Addendum No. 2

Project: **Smith Building Renovation**
Spindletop Center

Date: **June 16, 2022**

SHEET NUMBER
A000A

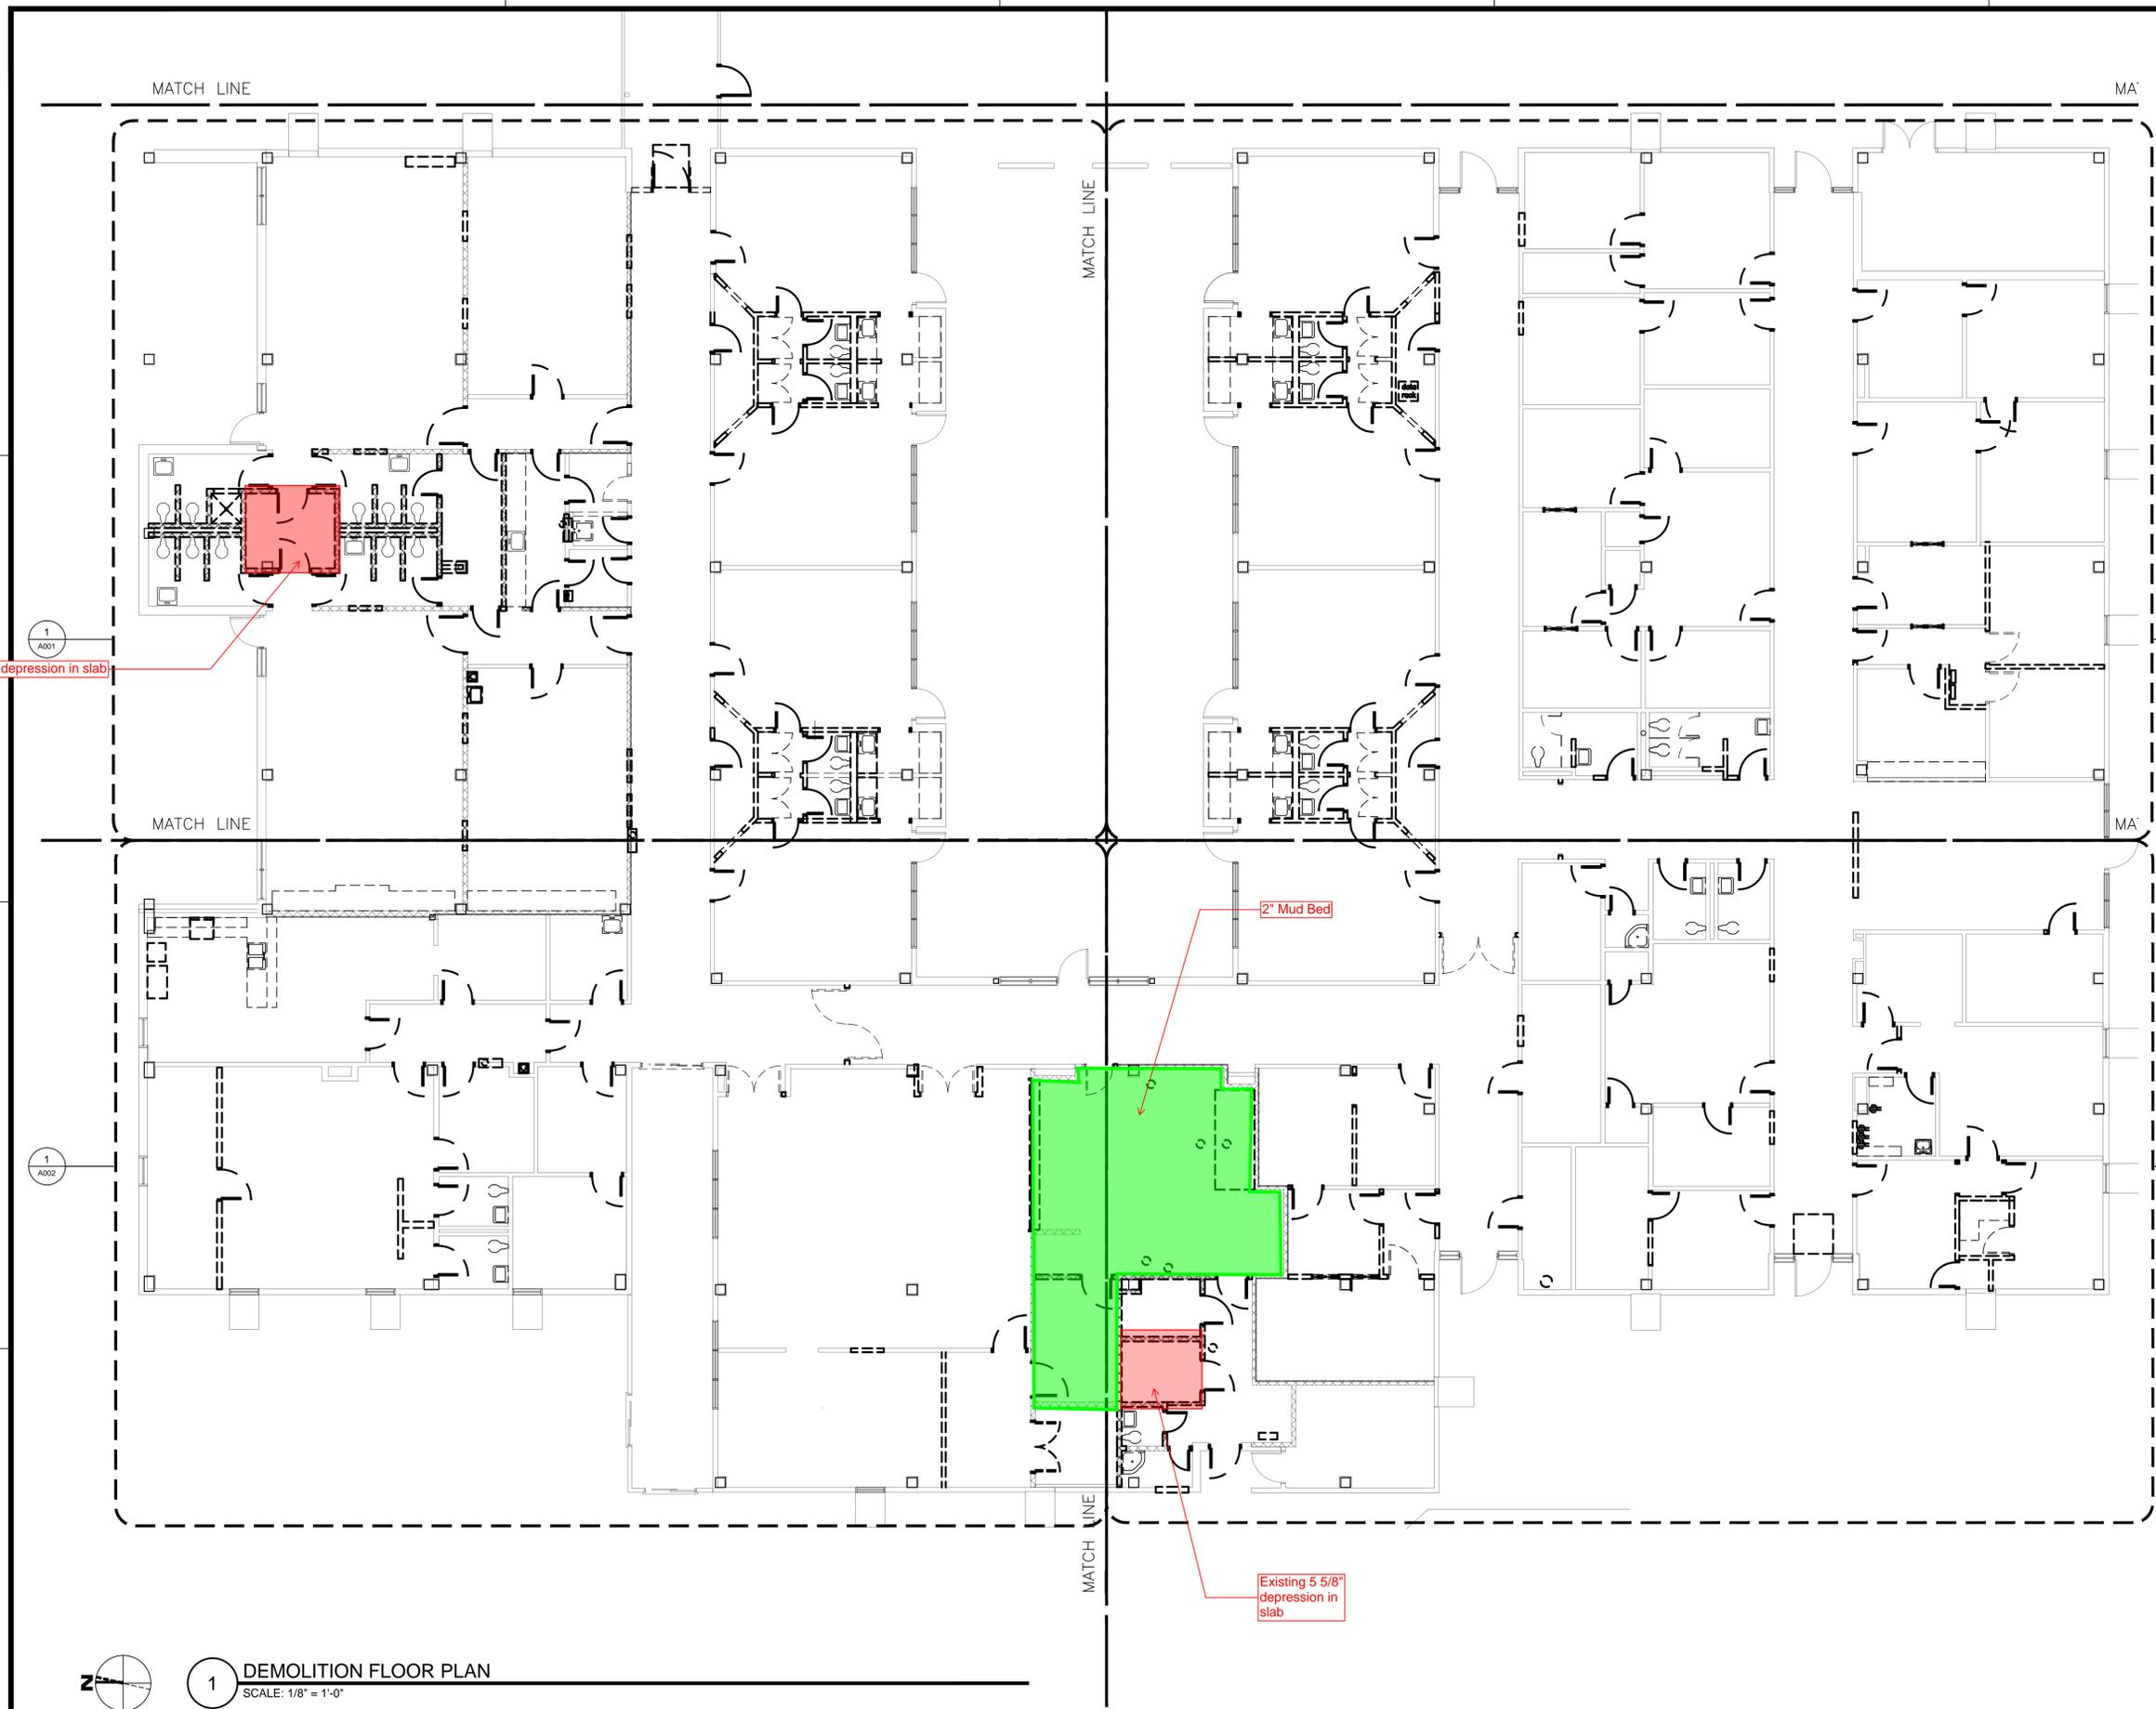
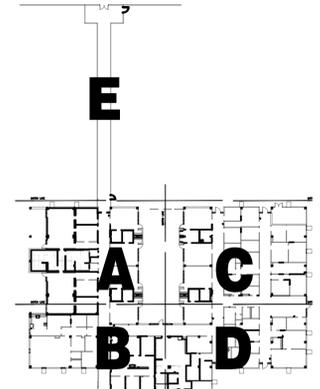
11. See attached A000A indicating existing depressions in slab. The 6x6 quarry tile floor in Break Room S114 is over a 2" mud bed. Abatement contractor will roughly chip the tile from the mud bed. Include in proposal cost to float smooth the floor as required to receive the new flooring. Grout flush an existing 5 5/8" depression in vicinity of Tlt S114B and Jan S114C. Grout flush an existing 2" depression in vicinity of Men S129.

1 A001
 2" depression in slab

2" Mud Bed

Existing 5 5/8" depression in slab
